Summary/Reason Statement for DRH12-00033

RIVER 8 CONDOMINIUMS

Planning Division Staff Report

Design Review Committee / March 14, 2012 Page 7 of 15

SITE PLAN/FIRST FLOOR PLAN

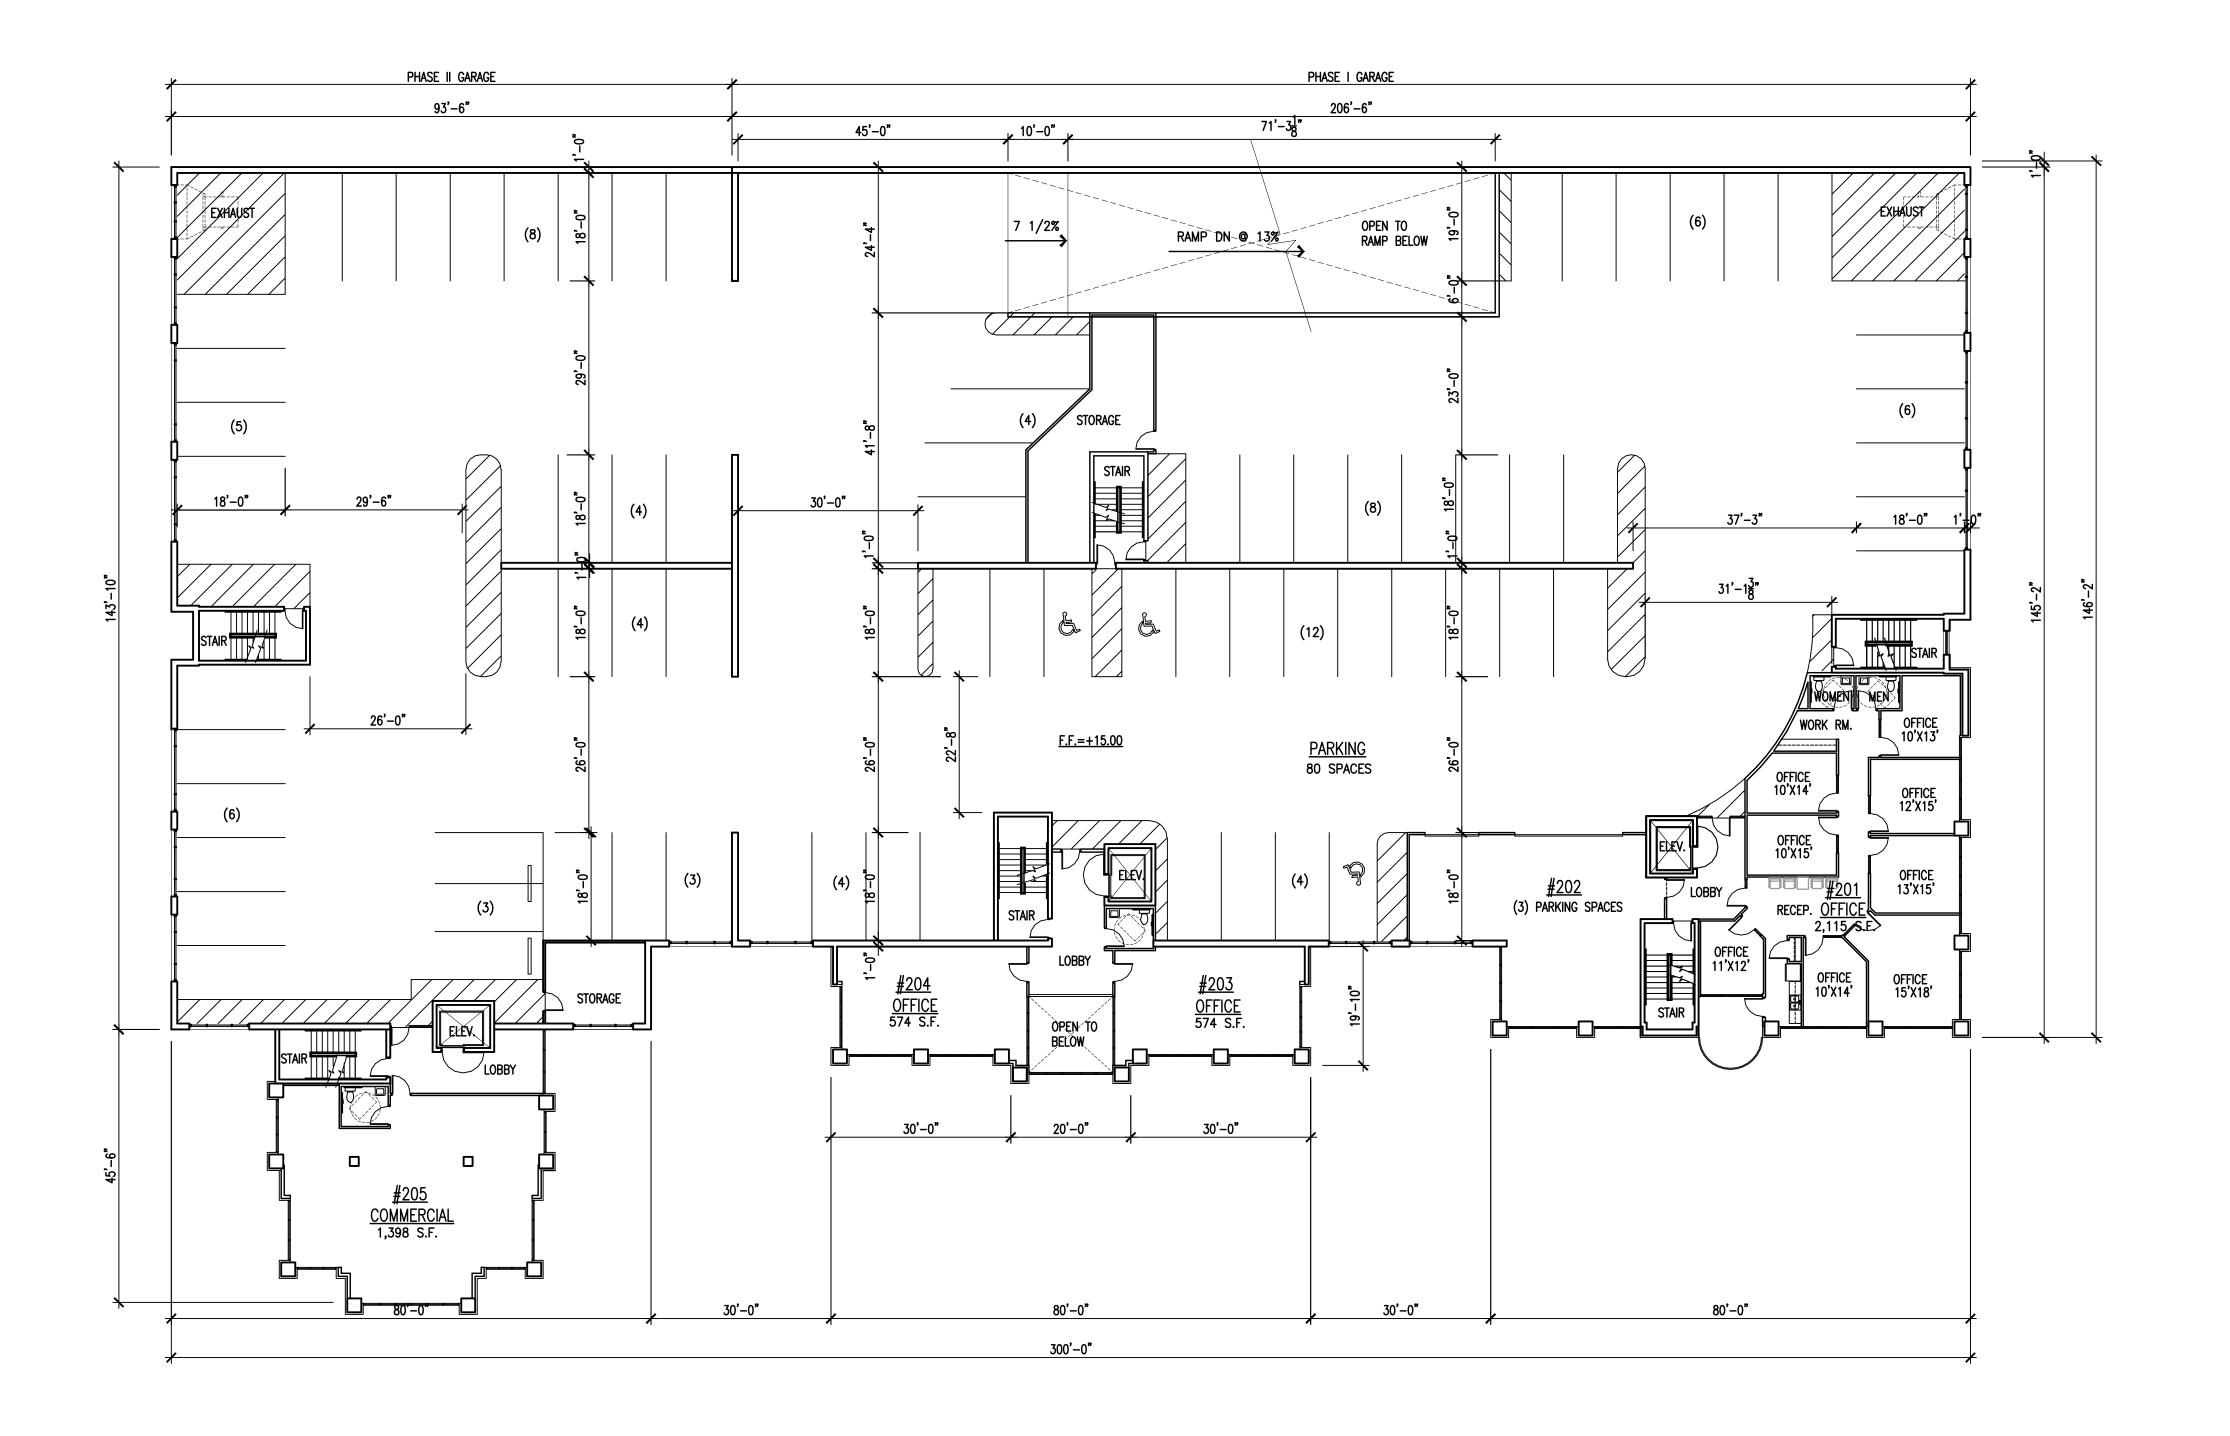
Staff has recommended the applicant close the unused driveways to match the required streetscape of each roadway, revise the streetscape along River Street and coordinate with the CCDC and the City of Boise in regard to the streetscape on 9th Street. These Conditions of Approval have been recommended to comply with the Objectives, Findings and Considerations of Sections 11-7-3.1, 11-7-3.2 and 11-7-3.3 of the Boise City Zoning Ordinance and the design related goals and policies of the Boise City Comprehensive Plan.

Vehicular access is provided to the site through a single 24-foot wide driveway intersecting 8th Street approximately 140-feet north of River Street. The driveway intersects 8th Street will provide access to the structured parking that is located to the first and second floors of the building. There are currently two driveways that intersect 9th Street, two driveways that intersect River Street and one driveway that intersects 8th Street. To provide a safe and continuous curb line and sidewalk, the applicant should close each of the unused driveways with standard vertical curb, gutter and sidewalk that match the required streetscape of each roadway.

- a. Close each of the unused driveways with standard vertical curb, gutter and sidewalk that match the required streetscape of each roadway.
 - b. Revise the streetscape along River Street to contain a minimum of an eight foot concrete sidewalk that is detached from the curb line by an eight foot planter strip that includes Class II street trees spaced every 50-feet on center as well as a second row of street trees located behind the sidewalk that are also spaced 50-feet on center.

LANDSCAPE PLAN

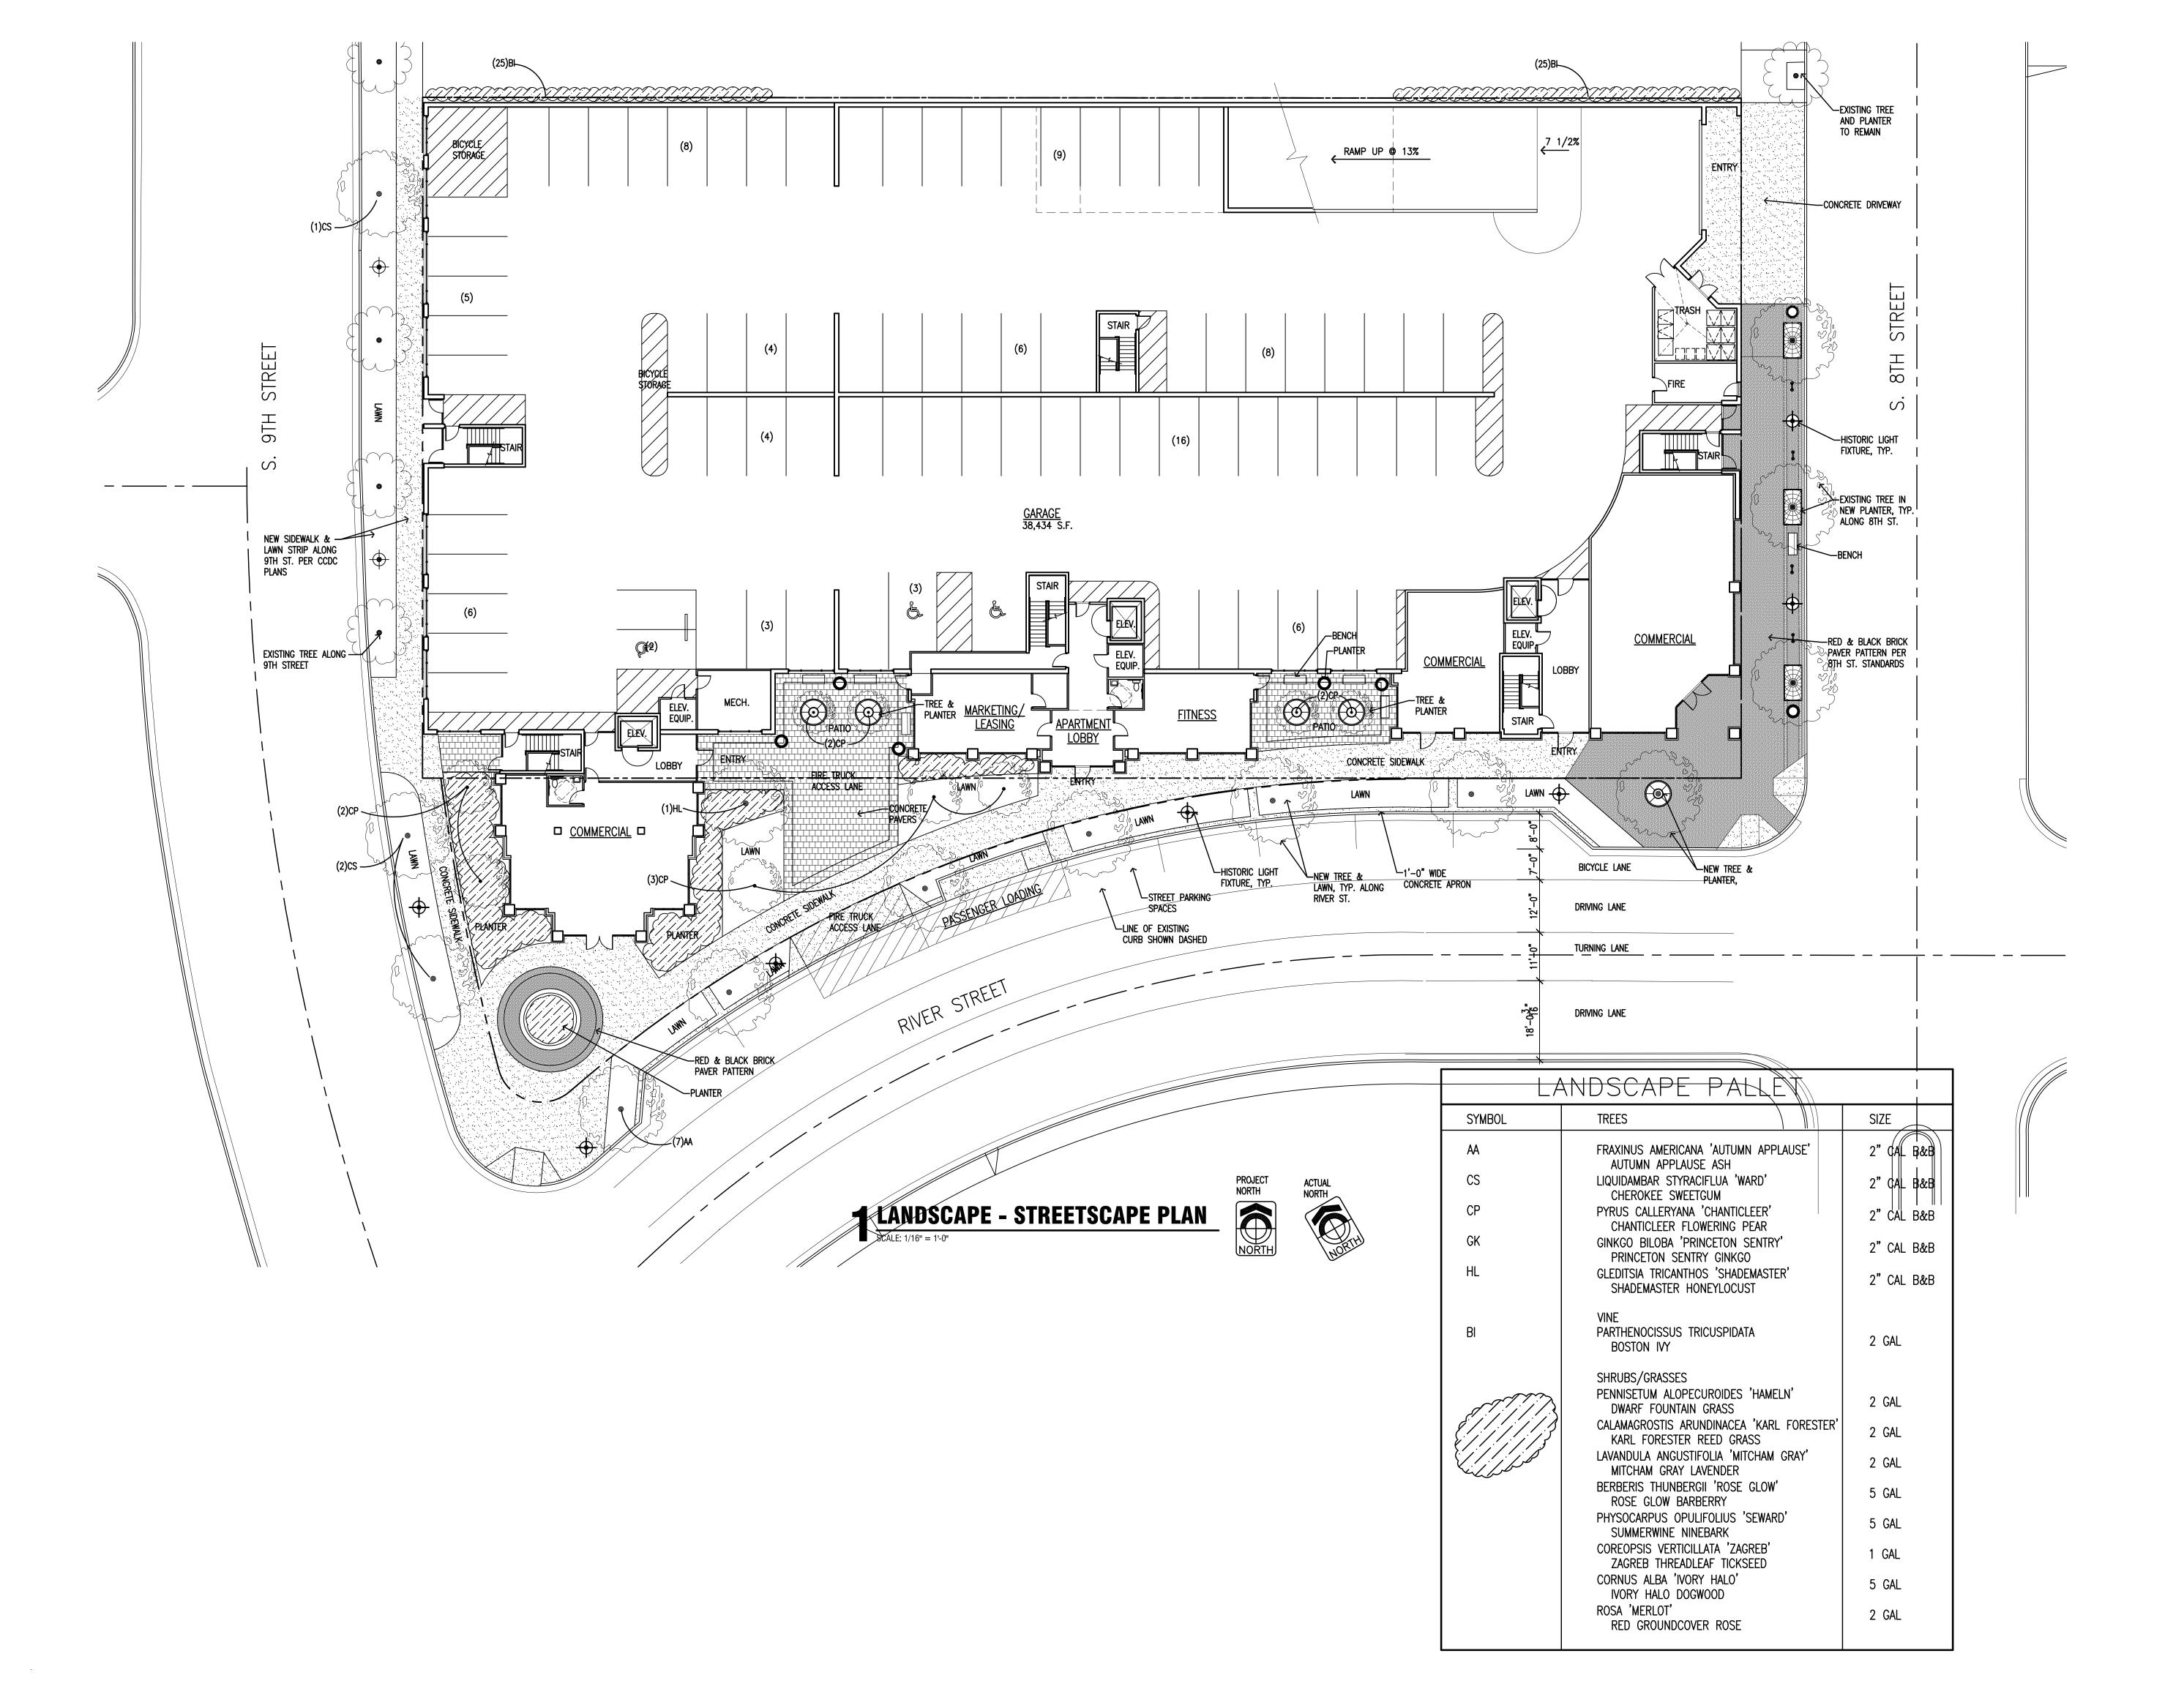
Staff has reviewed the submitted landscape plan which includes lawn and trees located within the planters that have been placed at the base of the building and throughout the adjacent streetscape. Overall, staff believes the landscape plan provides a mixture of species that will provide year round color that will soften the overall appearance of the site, are appropriate for the downtown area and will provide continuity with the landscaping and streetscape within the general area.

The trees selected for use around the above referenced plan are fine. Sorry for the delay, I was trying to catch up with Katina at CCDC about the streetscape on 9th. Apparently you talked to her about the same thing right before I did. Anyway, as far as Forestry is concerned the trees species are good to go on this project.

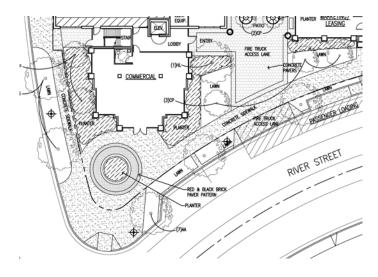
River Street is classified as an urban parkway streetscape within the 2007 Boise Streetscape Standards, which is intended to buffer pedestrians from the vehicles utilizing River Street while providing an aesthetically pleasing appearance. The applicant is proposing to construct the streetscape on River Street as a nine foot detached concrete sidewalk that is separated from the curb by a seven-foot grass-planting strip. The grass-planting strip is proposed to contain seven new Autumn Applause Ash trees. The new trees are spaced approximately 35-feet on center while the existing trees are spaced approximately 50 and 63-feet on center. According to the Downtown Boise Streetscape standards, the urban parkway streetscape should contain an eight-foot concrete sidewalk that is detached from the curb line by an eight-foot planter strip. The street section also calls for a double row of Class II street trees that are staggered and located approximately 50-feet on center. In order to begin a continuous streetscape along River Street and comply with the Downtown Boise Streetscape Standards, the applicant will be required to revise the streetscape along River Street to contain an eight foot concrete sidewalk that is detached from the curb line by an eight foot

planter strip that includes Class II street trees spaced every 50-feet on center as well as a second row of street trees located behind the sidewalk that are also spaced 50-feet on center.
